U.S. Department of the Interior BUREAU OF LAND MANAGEMENT

Well Name: SIXTEEN G`S Well Location: T24N / R9W / SEC 7 /

Notice of Intent

Type of Action: Plug and Abandonment

Planned P & A Schematic

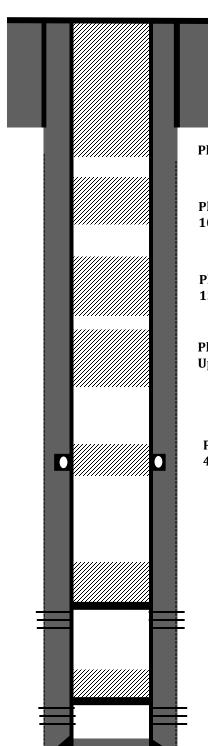
- a. Adjust Plug 4 (Mesaverde/Chacra) BOC to 3275' to cover BLM Geologist's Cliffhouse formation top pick @ 3225' and TOC to 2026' to cover BLM Geologist's Upper Chacra formation top pick @ 2126'. Plug 4 should at a minimum cover 3275' up to 2076'.

- b. Adjust Plug 5 (Fruitland/Picture Cliffs) TOC to 1246' to cover BLM Geologist's Fruitland formation top pick @ 1346'. Plug 5 should at a minimum cover 1746' up to 1296'.

- c. Adjust Plug 6 (Kirtland/Ojo Alamo) TOC to 402' to account for BLM Geologist's Ojo Alamo formation top pick @ 452'. Plug 6 should at a minimum cover 791' up to 402'. Plug 6 (Kirtland/Ojo Alamo) may be combined with Plug 7 (Surface) and go from 791' to surface.

-Modify Plug 4: Move the BOC to 3275' and the TOC to 2026' to account for the BLM geologist's picks for the Upper and Lower Chacra, the LaVentana tongue of the Cliff House and the Cliff House main.

-Modify Plug 5: Move the TOC to 1246' to account for the BLM geologist's pick for the Fruitand.

-Modify Plug 6: Move the TOC to 402' to account for the BLM geologist's pick for the Ojo Alamo.
